Item ID: D2580-1 Accept ***N900040100*** Setup Start ***NS1***
 Revision ID: Stop ***NS2***
 Item Name: 205 Skidtube bent detail
 Start Date: 03/01/2012 Start Qty: 2.00 ***2*** Cust Item ID:
 Required Date: 05/01/2012 Req'd Qty: 2.00 ***2*** Customer:
 Reference:

DRAWING NO. D2580	TITLE 205 SKIDTUBE ASSEMBLY	REV. E	DART AEROSPACE LTD ENGINEERING ORDER		D.E.O. NO. D2580-E-1	SHEET NO. SHEET 1 OF 1	SCALE NTS
DRAWN <i>UP</i>	CHECKED <i>ASS</i>	MFG. APPR. <i>EC</i>	APPROVED <i>[Signature]</i>		DE APPR. <i>[Signature]</i>		
DATE 11.12.13	DATE 11.12.13	DATE 11.12.13	DATE 11.12.13		DATE 11.12.13

CHANGE ALL C'BORED WELDED CROSSBOLT SPACERS TO SWAGED SPACERS

SECTION B-B, F-F, I-I
NOT TO SCALE

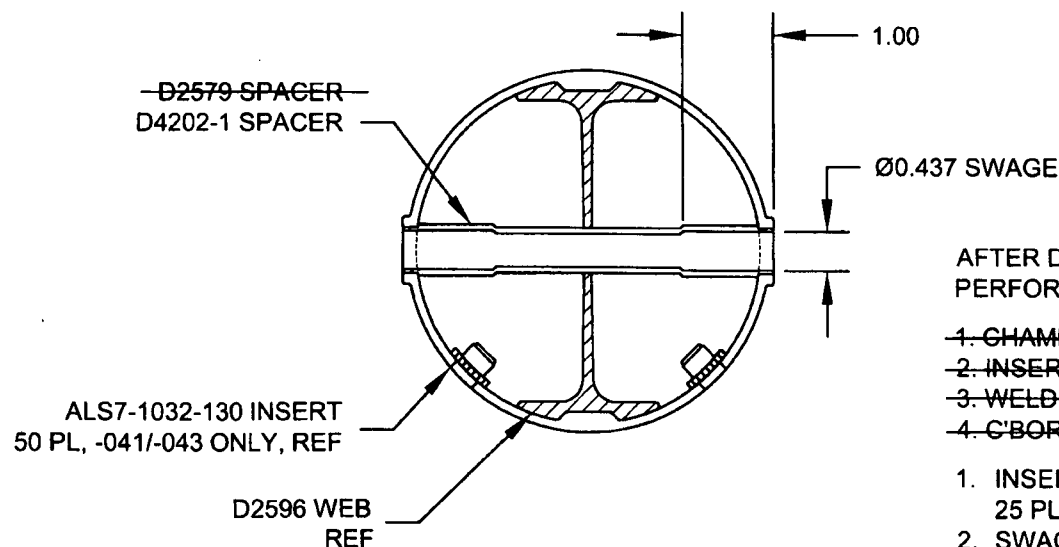
SECTION B-B, SECTION F-F, & SECTION I-I ARE AMENDED AS FOLLOWS
FOR ALL HOLES THAT WERE ORIGINALLY C'BORED:

AFTER DRILLING AND BENDING ASSEMBLY
PERFORM THE FOLLOWING FOR Ø0.508 HOLES ONLY:

1. CHAMFER HOLE 0.050 X 45°
2. INSERT D2579 SPACER (20 PLACES)
3. WELD INTO PLACE AND GRIND FLUSH
4. C'BORE D2579 SPACER TO Ø0.437 X 1.00 DEEP

*** FOR -045 SKIDTUBE ONLY:**
WELD 4X D2579 SPACERS PER DWG
IN LOCATIONS MARKED "NO C'BORE".
REF SHEET 4 OF DWG.

1. INSERT D4202-1 SPACER, 20 PL (-041) OR 20 PL (-045) OR 25 PL (-047)
2. SWAGE TO Ø0.437 X 1.00 DEEP PER QSI 002
3. TRIM / GRIND FLUSH PER QSI 002
